8751A-10

S E R V I C E N O T E

HP 8751A Network Analyzer

Modification to prevent test failure after adjustment

Figure 1. A1 CPU Board

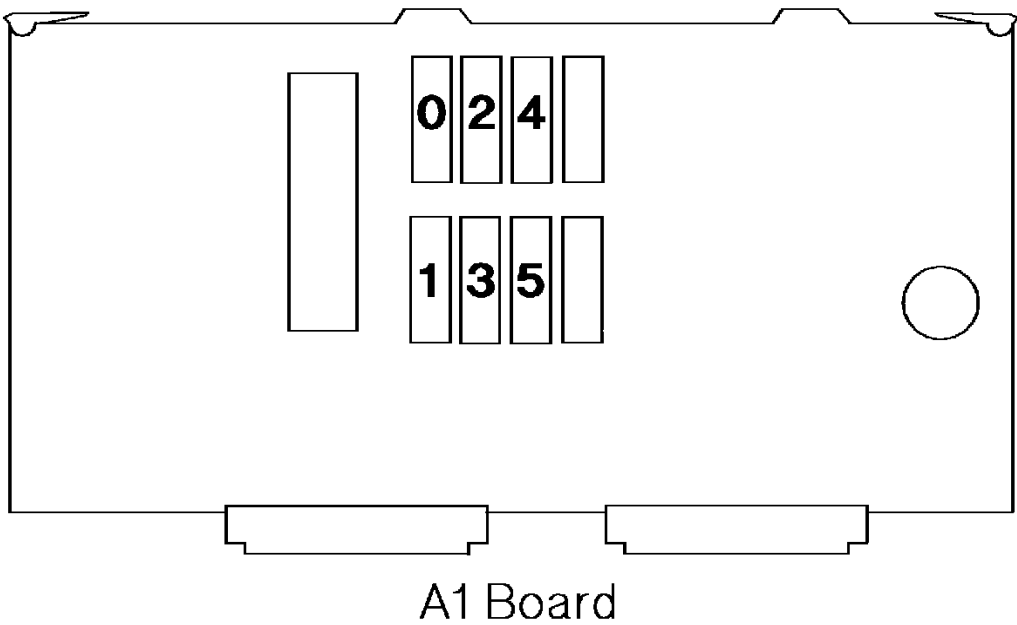
When you don't turn the instrument OFF after upgrading the Fractional-N Pretune Correction Constants or the STEP Oscillator Pretune Correction Constants, the HP 8751A doesn't output the proper frequencies and the frequency corresponding performance tests may fail.

1. Remove the top cover and shield plate.
2. Remove the A1 board.
3. Remove the programmed ROMs from the A1 board.
4. Install the new ROMs into the ROM sockets as follows:

Reference Designator	Part Number	Description
0 (A1U43)	08751-85501	ROM (Rev. 3.01)
1 (A1U44)	08751-85502	ROM (Rev. 3.01)
2 (A1U45)	08751-85503	ROM (Rev. 3.01)
3 (A1U46)	08751-85504	ROM (Rev. 3.01)

Reference Designator	Part Number	Description
0 (A1U43)	08751-85211	ROM (Rev. 3.01)
1 (A1U44)	08751-85212	ROM (Rev. 3.01)
2 (A1U45)	08751-85213	ROM (Rev. 3.01)
3 (A1U46)	08751-85214	ROM (Rev. 3.01)
4 (A1U47)	08751-85215	ROM (Rev. 3.01)
5 (A1U48)	08751-85216	ROM (Rev. 3.01)

5. Reinstall the A1 board.
6. Turn the HP 8751A ON. Confirm that the "POWER ON TEST FAILED" message is NOT displayed.
7. Press [SYSTEM], 'SERVICE MENU', and 'FIRMWARE REVISION'. Confirm that the firmware revision is 3.01.
8. Turn the HP 8751A OFF.
9. Reinstall the shield plate and the top cover.
